AGENDA
PLANNING & ZONING COMMISSION
THURSDAY, May 28, 2020
7:00 P.M. Virtual Meeting *

Planning and Zoning Commission Agenda Memorandum

**Re: Builder's FirstSource, Major Site Plan
LU20-13-15**

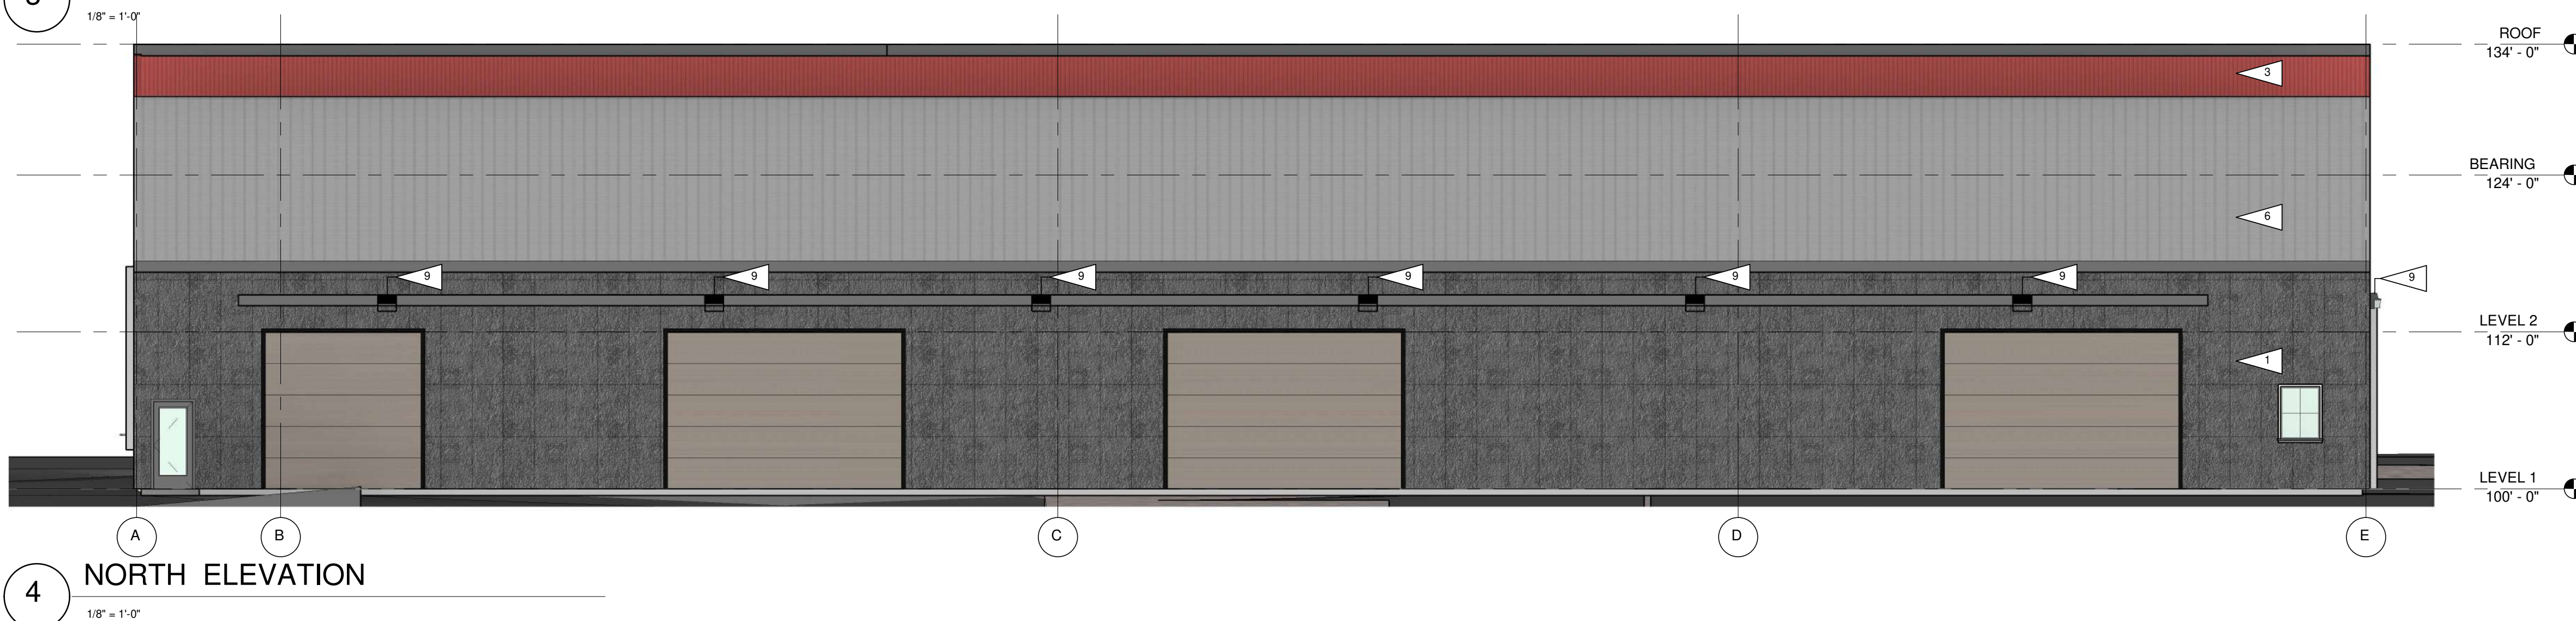
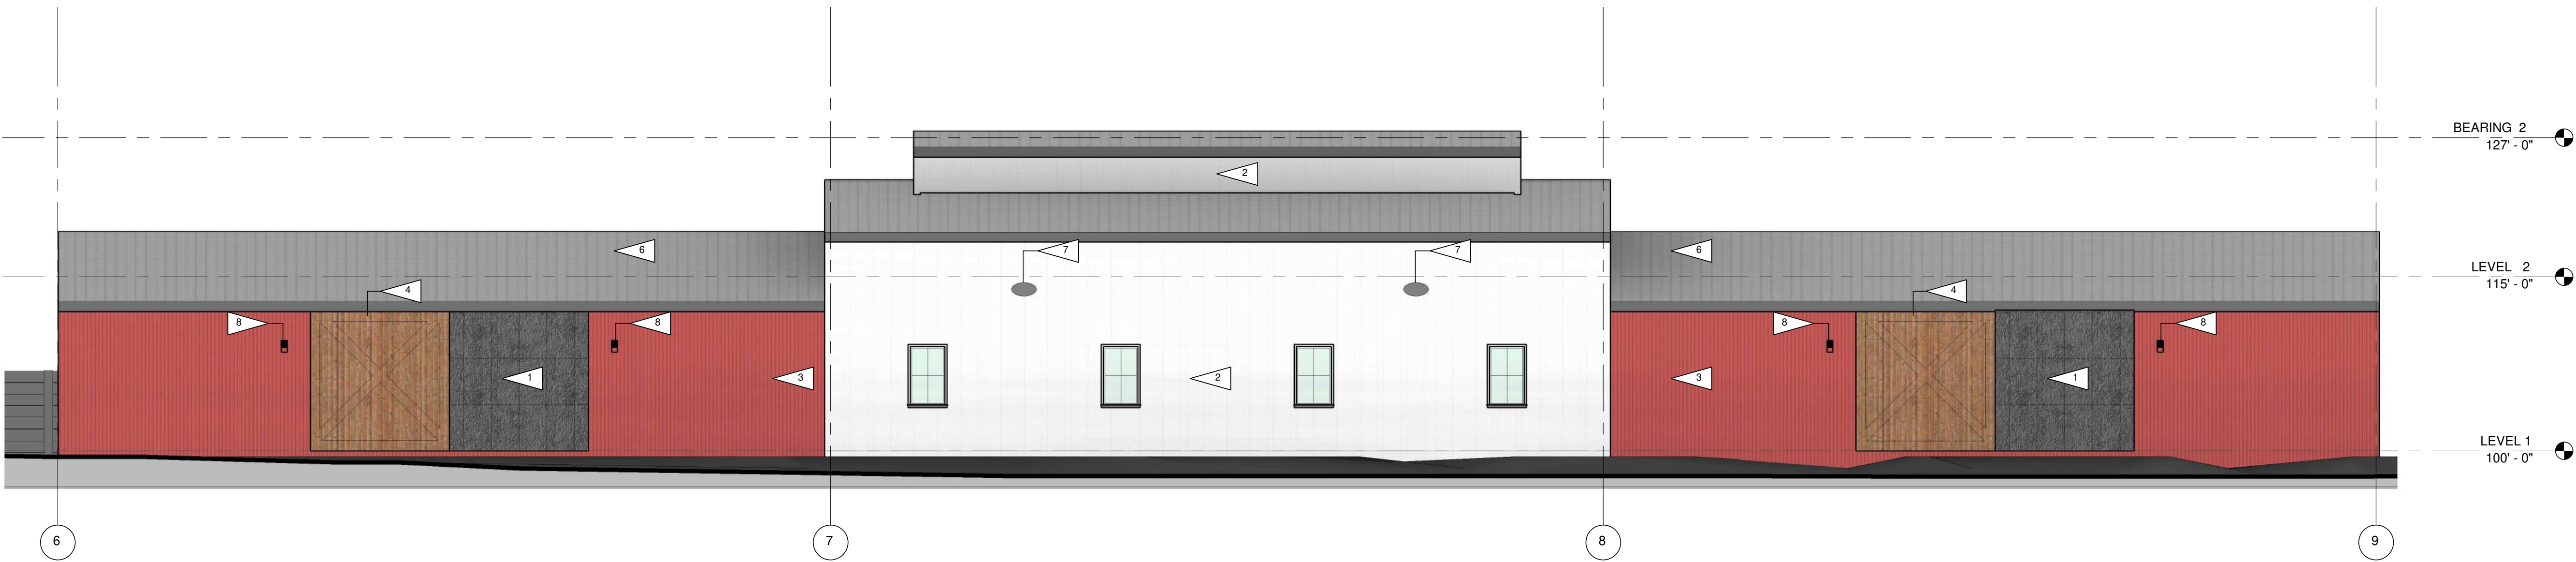
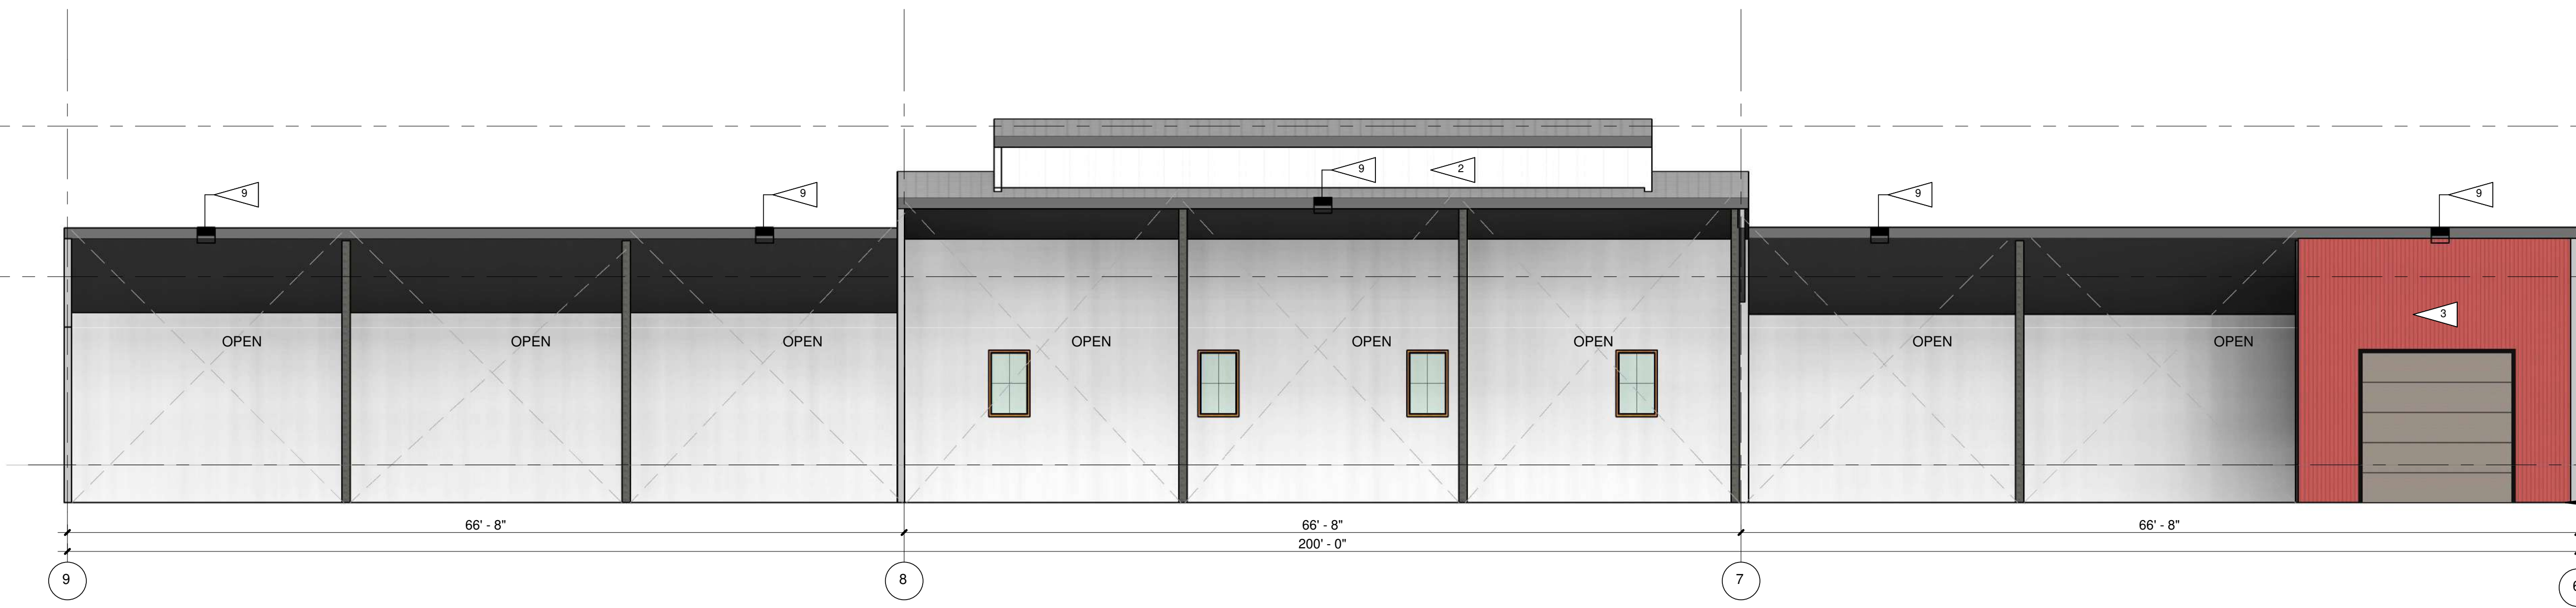
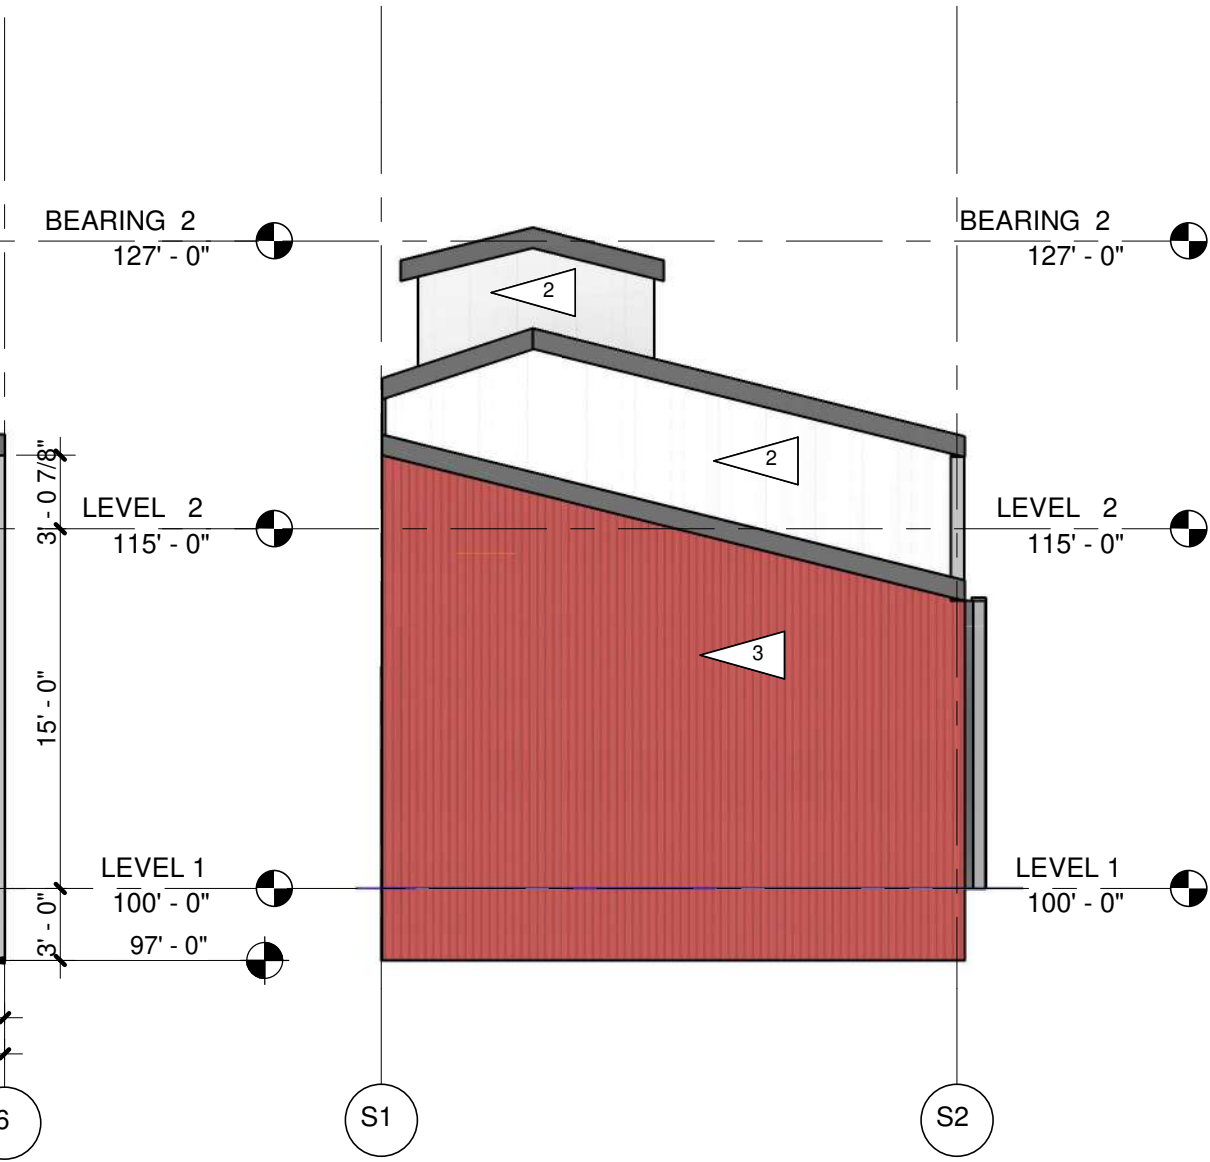
Light fixtures 7 and 8, shown on sheet A4.01, are questionable as to the shielding of the light source. The light source of the fixture is not to be visible from the property line or the right of way.
